Six Chuter Inc.  
**SAFETY DIRECTIVE**  
SB 2007-1

<b>LEVEL</b>	<b>ADVISORY</b>
<b>DATE</b>	Friday, October 05, 2007
<b>SB NUMBER</b>	SB 2007-1
<b>APPLICABLE MODELS &amp; CATEGORIES</b>	SR5 XP <b>Experimental Light Sport Only</b>

1.3.1 This advisory bulletin is issued due to a reported failure of a landing gear strut bolt (AN 4-23) while transporting the powered parachute by trailer.

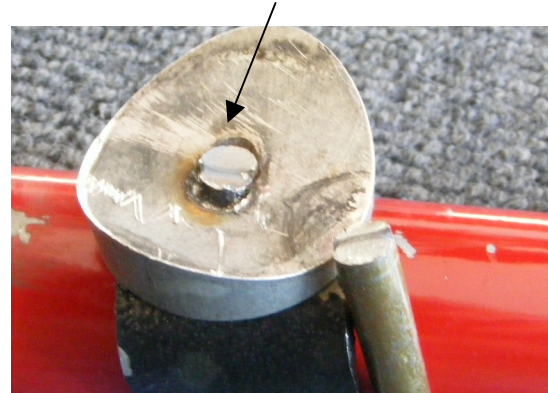
1.4.1 **Description of failure:** Left landing gear strut bolt (AN 4-23) broke at approximately 3/16 inch from the bolt head at the attachment point on the airframe main tube structure. The failure occurred during the transportation of the aircraft and not during aircraft operations. This aircraft was retrofitted with shock absorbing suspension system marketed by Sixchuter Inc. ***There are no other known or reported incidents***

**Note: Bolt Head**

**Note: Ridge in bolt body**

This bolt is one of many bolts that were placed approximately two years ago during the rebuild of the airframe. During the rebuild, the AN4 bolts were tightened to 100 in. lbs. of torque.

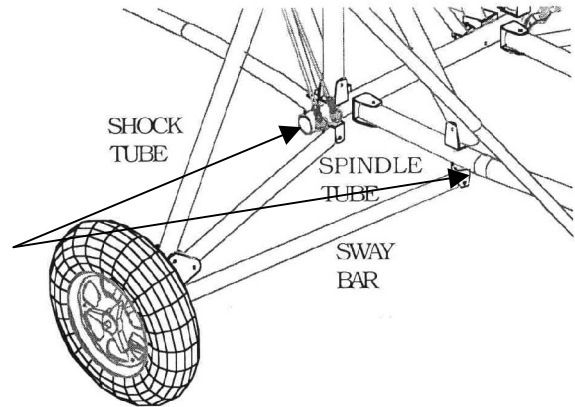
As the landing gear is a critical component of the aircraft, the strength and dependability of these components is essential. The outboard Spindle and Shock Tube assemblies are substantially re-enforced with multiple attachment points. The outboard Sway Bar and inboard Spindle and Sway Bar tubes are attached with a single AN4 bolt (see illustration).

- 1.5.3 If the owner discovers signs of stress Six Chuter recommends replacing the bolt with An AN 5 of similar length. Replacing the AN4 bolts with AN5 bolts would yield an estimated 160% increase in Breaking and Yield Strength. The larger diameter bolts also must be equally matched with the attaching brackets and tubing.

- 1.13.1 AN4-23 Bolt can be replaced with AN5-23
